### **IN THE DRAWINGS**

Corrected drawings are supplied herewith.

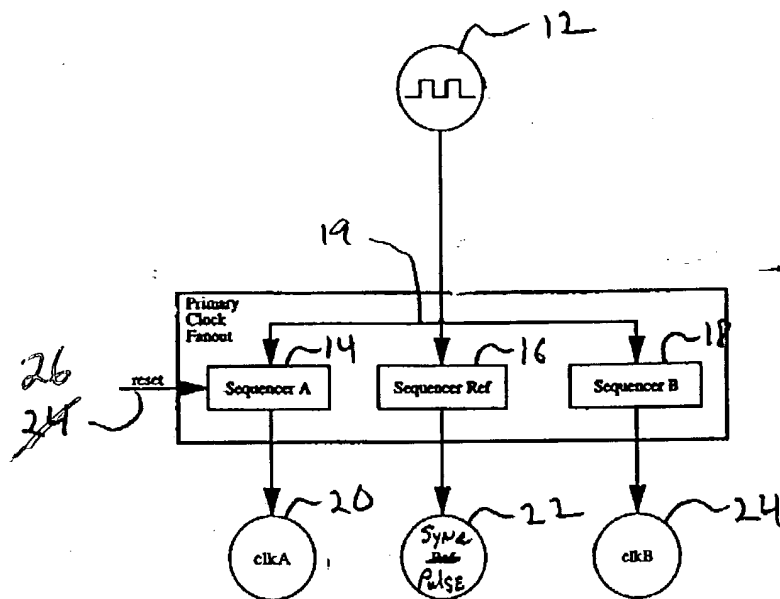
The drawings were objected to because in Fig. 1 the reset is labeled 24 while in the specification the reset is labeled 26. The label in Fig. 1 has been as per the attached red-lined drawing.

Fig. 8

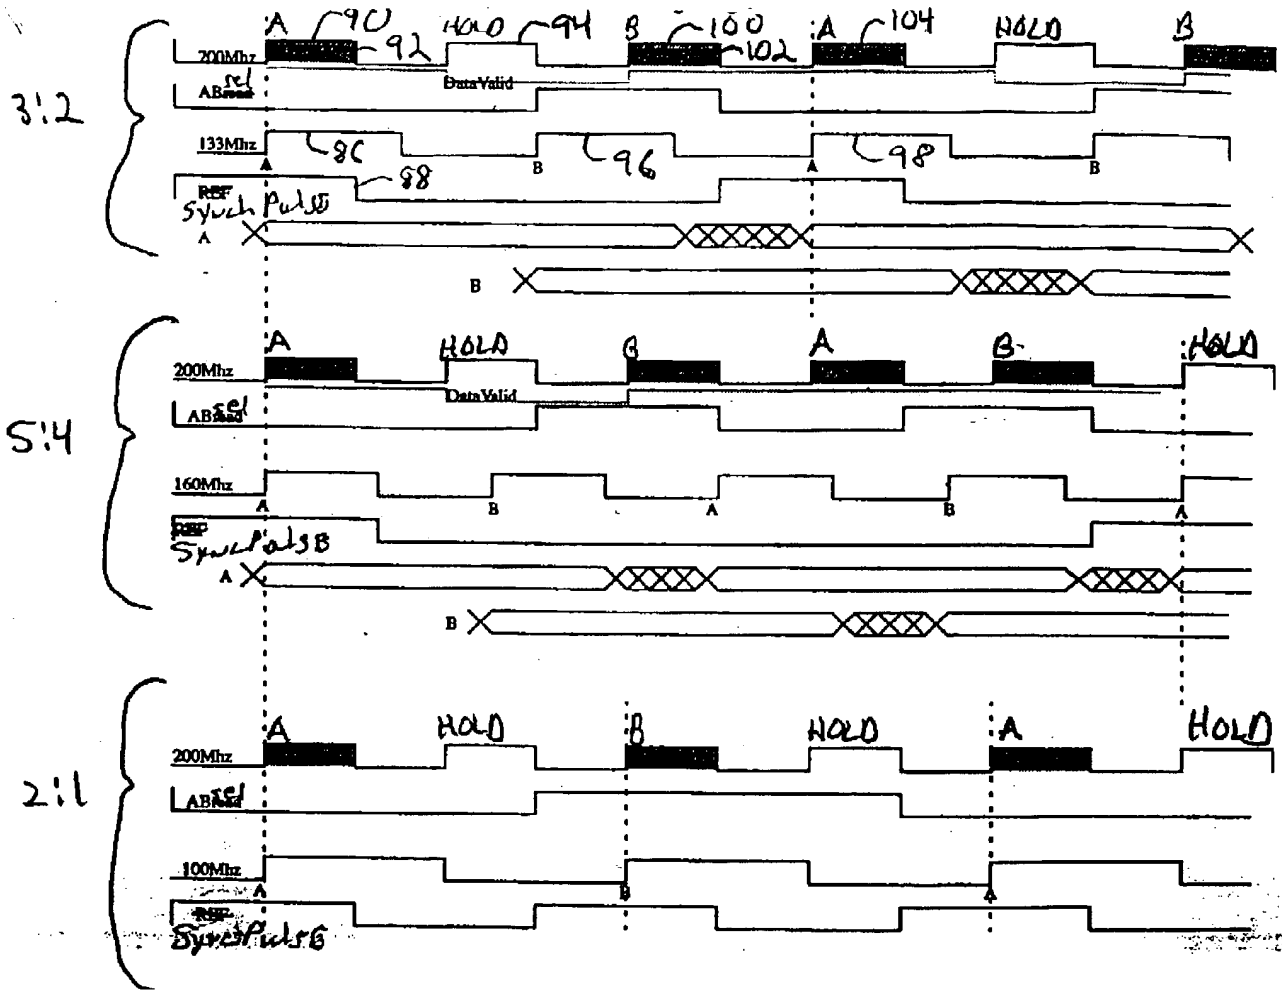
The drawings were objected to for failing to comply with 37 CFR 1.84(p)(5) because they include the following reference sign(s) not mentioned in the description: ref. 108. Applicant was unable to find a reference number 108. A copy of Fig. 8 without the reference number 108 is attached.
